**FIRST AMENDMENT TO
REQUEST FOR PROPOSALS:**

**FOR CONSTRUCTION SERVICES RELATED TO THE
ROGER WILLIAMS PARK GATEWAY PROJECT
LOCATED AT 1197 BROAD STREET**

ADDENDUM 01

Project Name: Roger Williams Park Gateway Center
Date: April 6th, 2021
Project No: 2717.00

8 PVD PARK STANDARD WIRE MESH 6' HIGH FENCE DETAIL
 SCALE: 1"=1'-0"

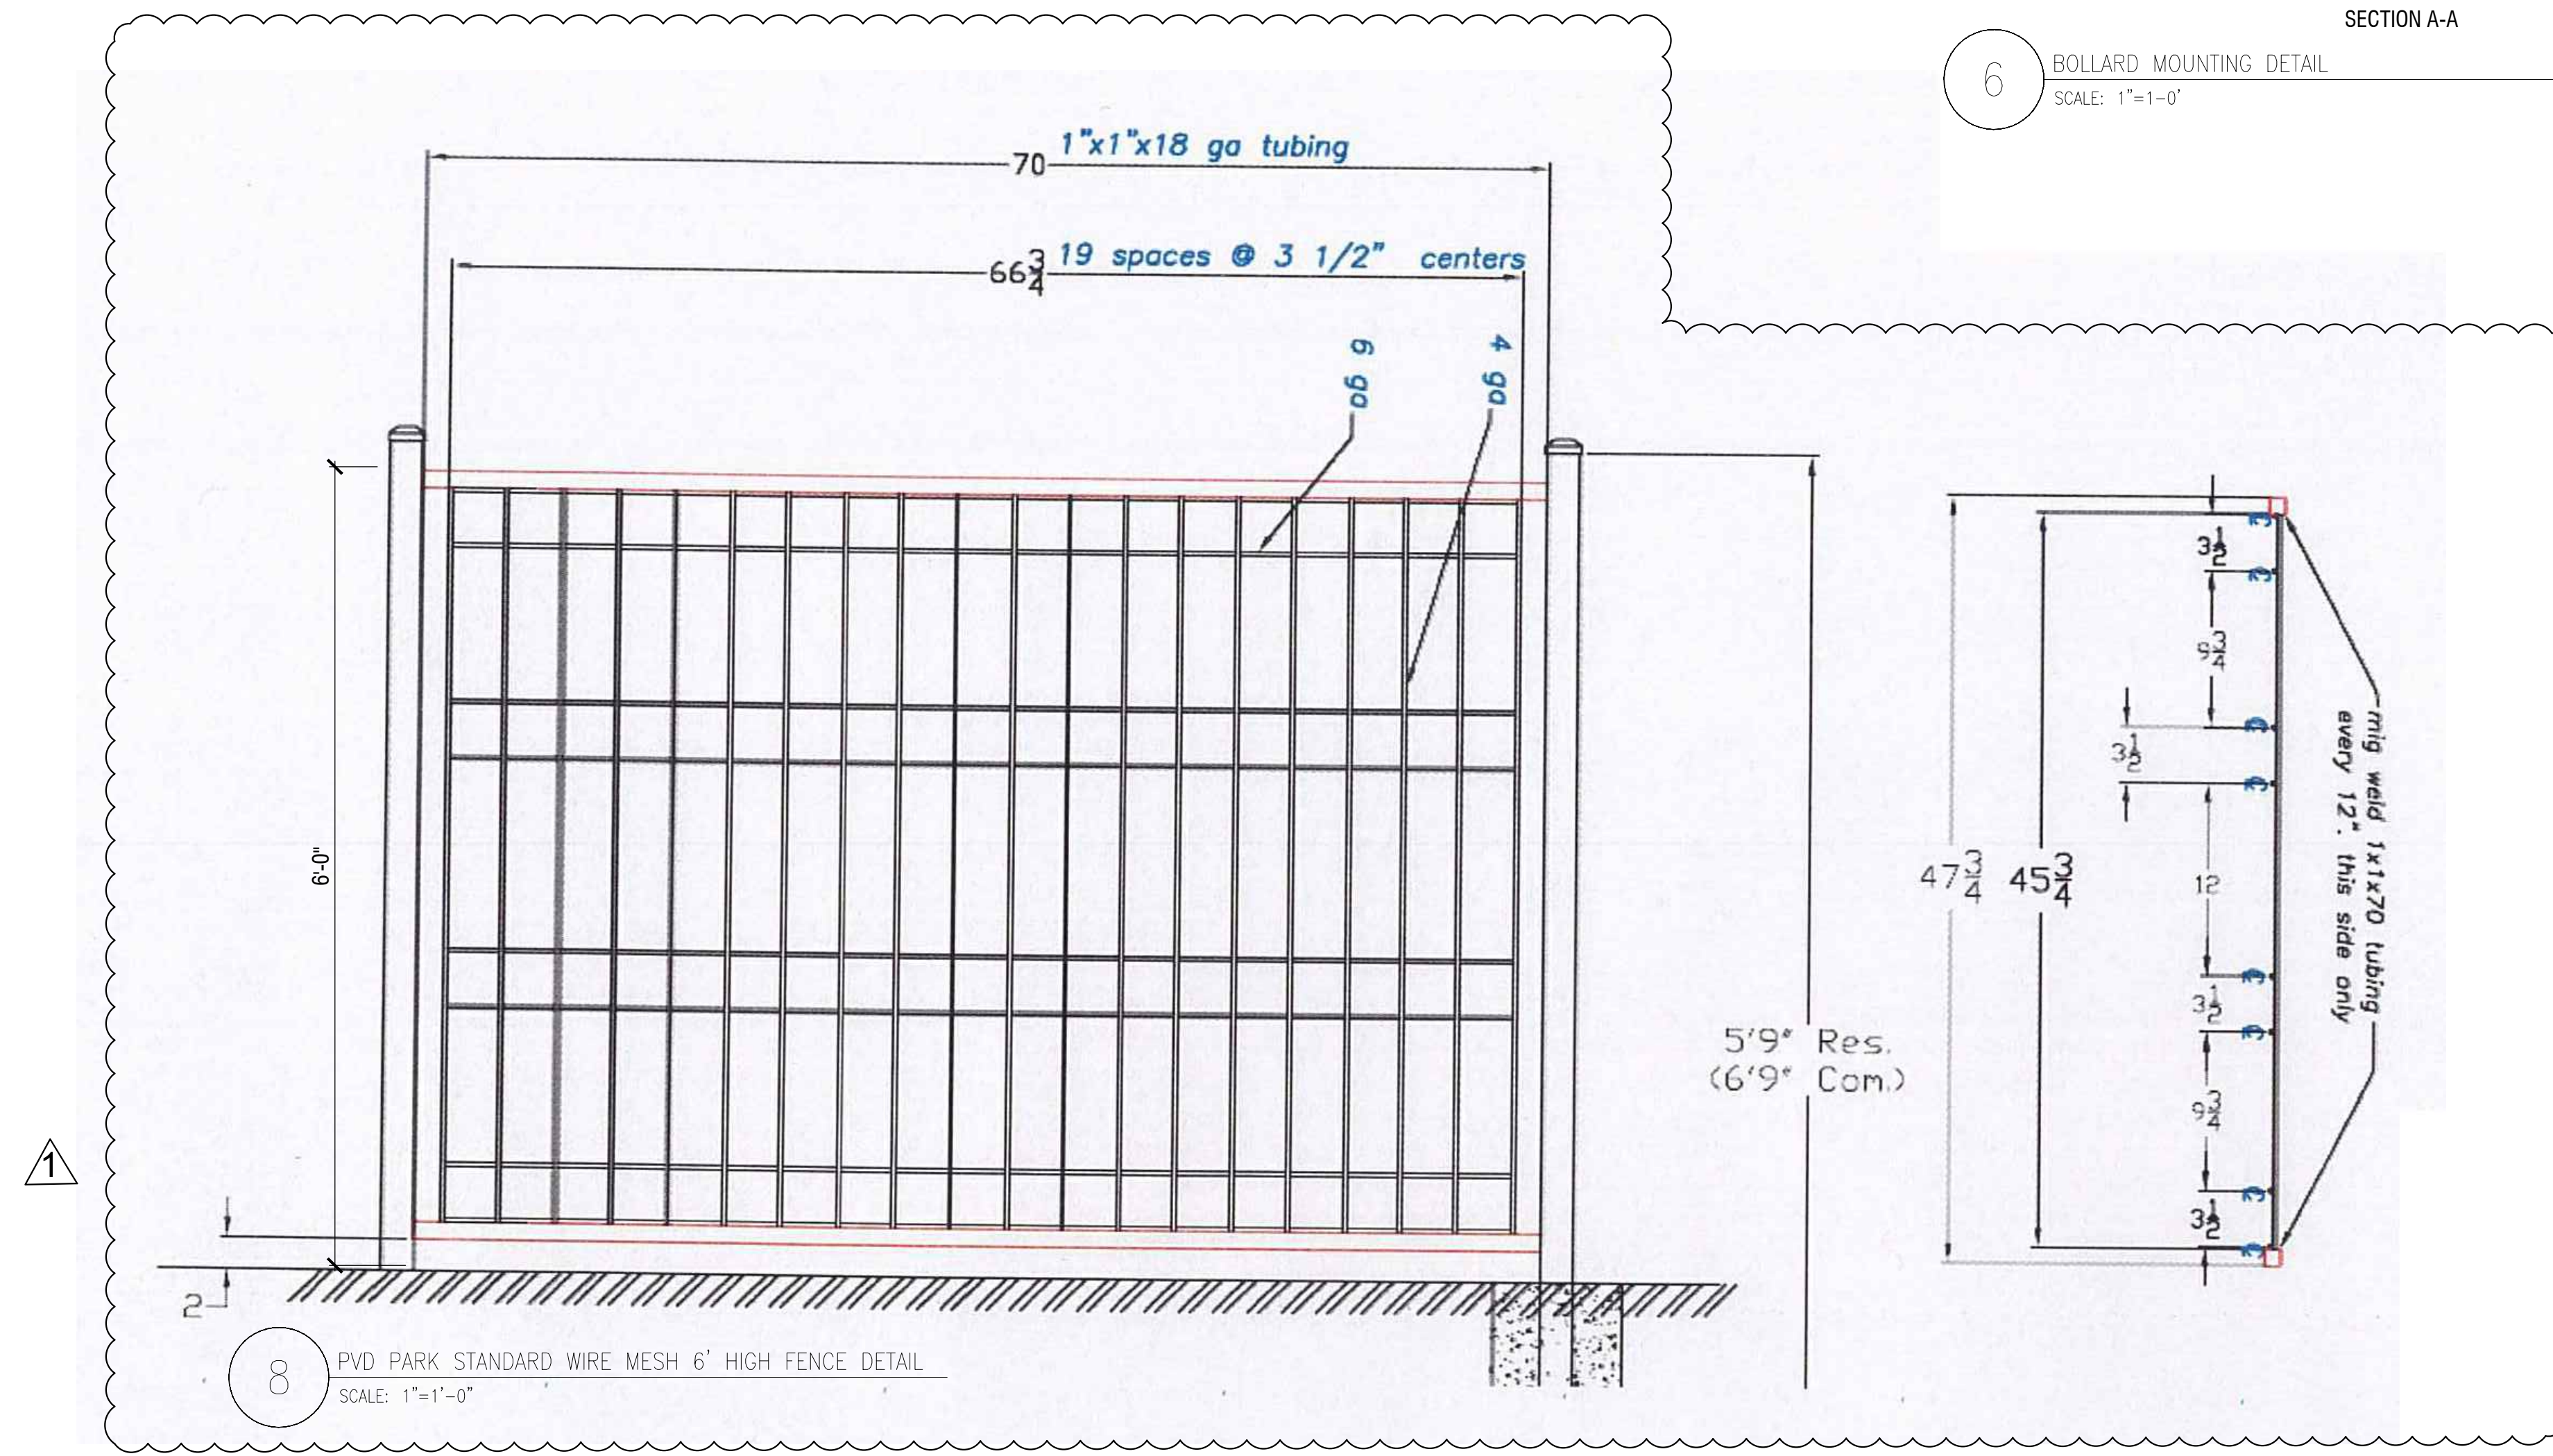
L-7.00-DETAILS

3. Added PVD Parks Dept. standard welded wire fence (Patriot Ornamental Wire Fence - 72" high 4 gauge vertical) to be installed along the north property line as indicated in the plans. See attachment for specifications and installation instructions.
